# **Product Change Notification**

Product Group: OPT/Fri Aug 20, 2021/PCN-OPT-1197-2021-REV-0

## Change of PCB for TFBS4650.../TFBS4711... Series (IRDC)

# Change of PCB for TFBS4650.../ TFBS4711...Series

#### A. Material changes

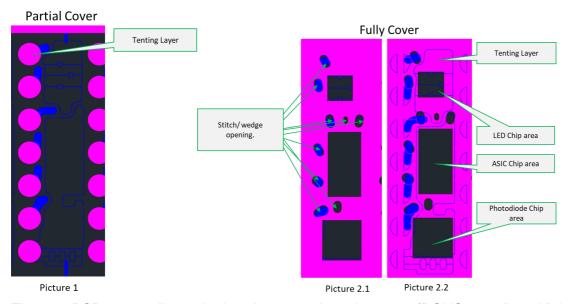
Before (current PCB)

- 1. Au plating
- 2. Partial tenting layer
- 3. Full Moon tunnel
- 4. Tenting Layer Material AUS402

#### After (new PCB)

- 1. Nickel Palladium Gold plating
- 2. Full tenting layer
- 3. 1/2 Moon tunnel
- 4. Tenting Layer Material AUS410

A full tenting layer will cover inactive area on top of the PCB to have better epoxy coverage and epoxy bridging control over Die Attach process:
